REFERENCE:	TSB: 08-343-25 REV. A GROUP: 08 - Electrical	Date:	December 3, 2025	REVISION:	08-343-25
VEHICLES AFFECTED:	<p>2025 (DJ) RAM 2500 Pickup 2025 (D2) RAM 3500 Pickup 2025 (DP) RAM 4500/5500 Cab Chassis 2025 (DD) RAM 3500 Cab Chassis This bulletin applies to vehicles equipped with the Cluster 7.0" TFT Color Display (Sales Code JAL).</p>	MARKET APPLICABILITY:			
		<input checked="" type="checkbox"/> NA <input checked="" type="checkbox"/> MEA <input checked="" type="checkbox"/> SA <input checked="" type="checkbox"/> IAP <input type="checkbox"/> EE <input type="checkbox"/> CH NOTE: This bulletin applies to the North America, South America, India & Asia Pacific and Middle East & Africa markets.			
CUSTOMER SYMPTOM:	<p>Customers may experience one or more of the following:</p> <ul style="list-style-type: none"> • **The IPC does not display the correct Tire Pressure Monitoring System (TPMS) graphic in the IPC (For dually vehicles only) Fig. 1.** • While driving, resetting the Diesel Particulate Filter (DPF) gauge causes the IPC to freeze on that screen. The left-side steering wheel controls (used for navigating the IPC) becomes unresponsive while the right-side controls for cruise

Fig. 1

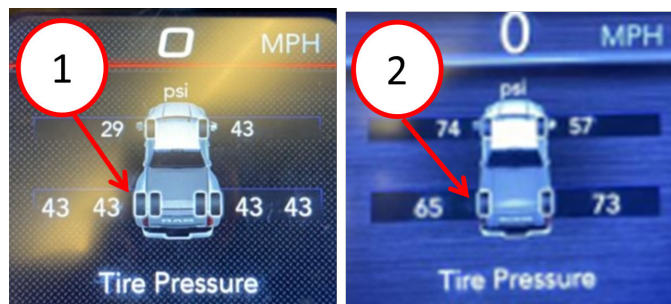
This bulletin supersedes Technical Service Bulletin (TSB) 08-343-25, date of issue October 14, 2025, which should be removed from your files. All revisions are highlighted with ****asterisks**** and include an additional Customer Symptom and figure.

****Correct And Incorrect Dually Tire Pressure IPC Screens****

1 - CORRECT Dually Tire Pressure IPC Screen
 2 - Incorrect Dually Tire Pressure IPC Screen

This bulletin involves updating the IPC with the latest available software.
